FIRE SAFETY INSPECTION REPORT

Factory Name: L'usine Fashion (Mawna Unit)

ACCORD ID: 12438

Date: April 17, 2016

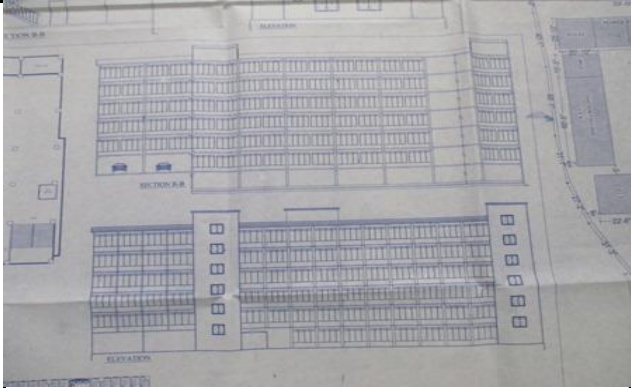
SI No.	Category	Findings	Required Action	Remediation Time Frame	Pictorial Evidence
6	Fire Rated Construction	Compressor room is not properly separated by fire rated construction with exit excess way.	Compressor room shall be separated from other occupancies by a minimum 1-hr (2-hr for high-rise building) fire rated construction (wall, floor, slab etc.). Seal all penetrations and openings (door, window etc.) should be protected by 0.75-hr (45 min) fire rated materials to maintain the fire separation if required. All exhaust systems shall discharge to the exterior of the building in a safe location. Or Relocate it to exterior of the building and maintain a minimum 3m (10 ft.) spatial separation distance from the building.	Within 2 months
